Marine Safety Center Vapor Control System (VCS) Plan Review Information Sheet (PRIS)

Vessel Name	CBC 94	Shipyard	Jeffboat
Official Number	1141498	Hull Number	03-2972 & 03-2977

VCS Approval Letter C1-0304452 dated 25Mar03

LIQUID TRANSFER RATE VS FACILITY VAPOR CONNECTION PRESSURE

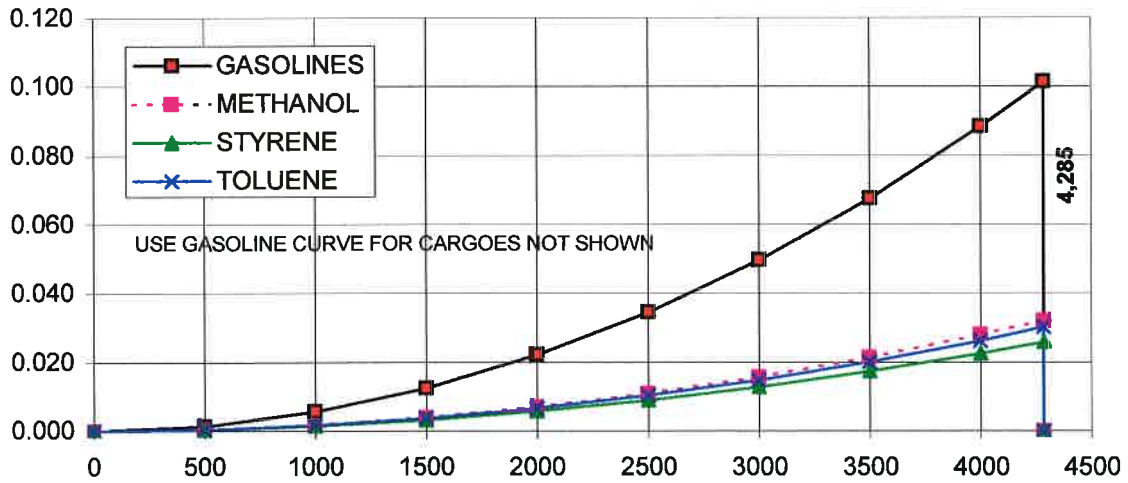
CBC 90 thru CBC 99
03-2972 to 03-2977 and 03-2990 to 03-2993
CBC 124 thru CBC 131
01-2746 TO 01-2751, 02-2965, 02-2966
4,285 BBL/HR MAX TRANSFER RATE
